RHODES BUSINESS PARK

TECHNICAL NOTE

Flood Zone Analysis Modelling Results

Document No: 40055-BGL-XX-XX-TN-C-00006

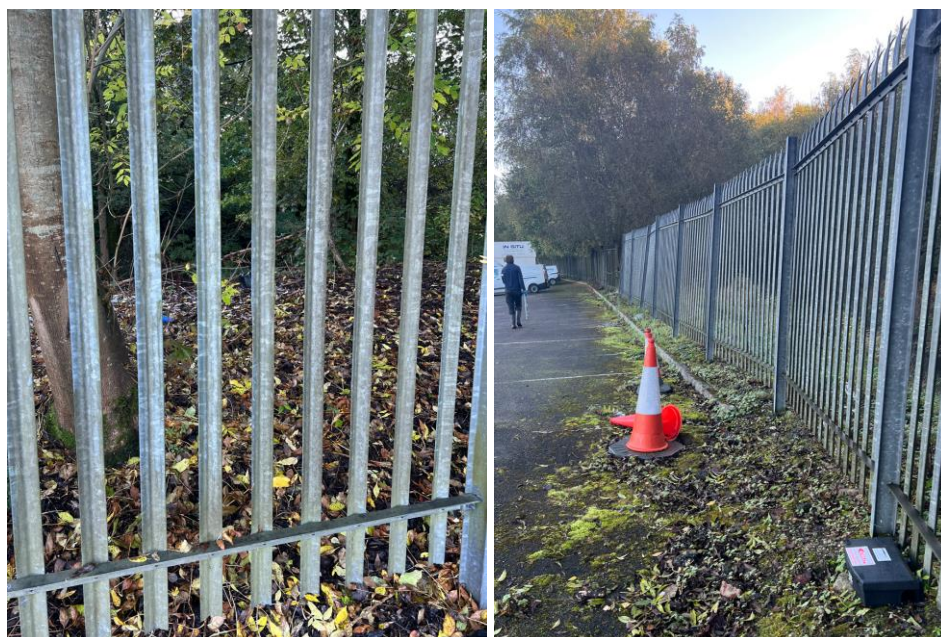
EA Comment:

In particular, the FRA fails to:

Consider how people will be kept safe from the identified flood hazards

- Consider the requirement for flood emergency planning including flood warning and evacuation of people for a range of flooding events up to and including the extreme event. *These have been addressed in this technical note.*
- Flood risk mitigation measures to address flood risk for the lifetime of the development included in the design are inadequate because they will not make the development resilient to the flood levels. Consequently, the development proposes inadequate:
 - Flood storage compensation. *From the JBA report the flood depth over the proposed development do not exceed 150mm on average over the site footprint, this results in a*

displacement volume of approximately ~600 litres, this is considered to be negligible over the greater flooded area resulting in less than 5mm level increase .

- Raised finished floor levels. FFLs should be set 600mm above the flood level, including climate change. The proposed FFL is set at 70.900m AOD – modelled flood levels are predicted between 70.10 – 70.20m AOD for the 1:100+CC event.
- Resistance and resilience measures. These have been addressed in the previous section.
- Safe access and egress routes. These have been addressed in the previous section.
